SUBJECT: Application for a Certificate of Compliance for the Mixed Oxide Fresh Fuel Package, Revision 1, DOCKET No. 71-9295

Reference: NRC Letter, "Request for Additional Information – Mixed Oxide Fresh Fuel Package – Docket No. 71-9295," dated December 8, 2004

REQUEST FOR ADDITIONAL INFORMATION

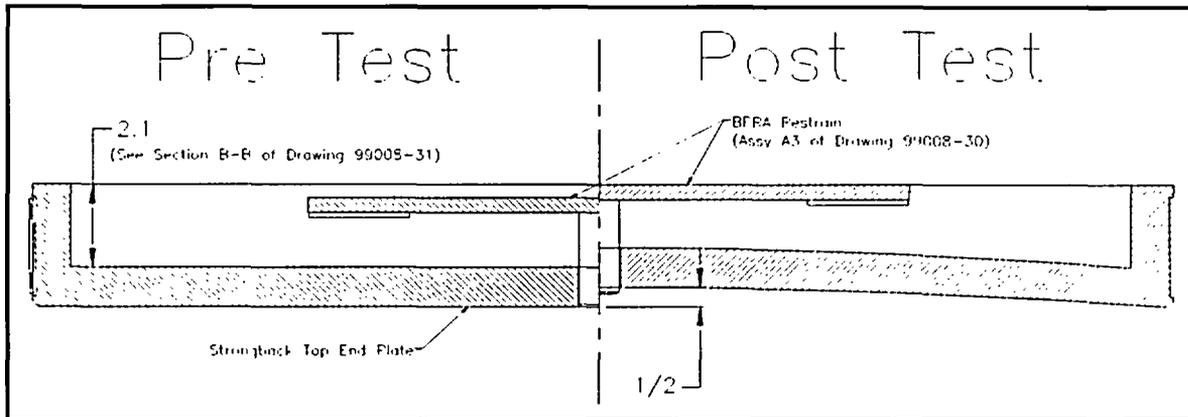
- 2-11 Provide the basis for using the video records taken of the impact limiter crushing to estimate package decelerations for the drop test. If only constant decelerations were assumed for the duration of impact, obtain and justify peak deceleration estimates and perform structural re-analyses, as appropriate, for package.

It is unclear as to how the video records were used to obtain package decelerations, average or peak.

Response: The package decelerations extracted from the video records were determined by numerically differentiating the displacement versus time twice of several fixed points on the body. With a frame speed of 1,000 frames per second (fps), each time step was 0.001 seconds per frame. Using a known package dimension to benchmark the video image scale, the displacement of the selected body fixed points were then determined for each time step, from immediately prior to and to the end of the impact event. The displacement-versus-time data then was used to calculate velocity (first derivative) and acceleration (second derivative). This method ensured that the peak accelerations were detected and evaluated rather than using an average deceleration for the impact event. Figure 2.12.3-16 illustrates this technique for comparing the velocity of two different tests of the same drop orientation.
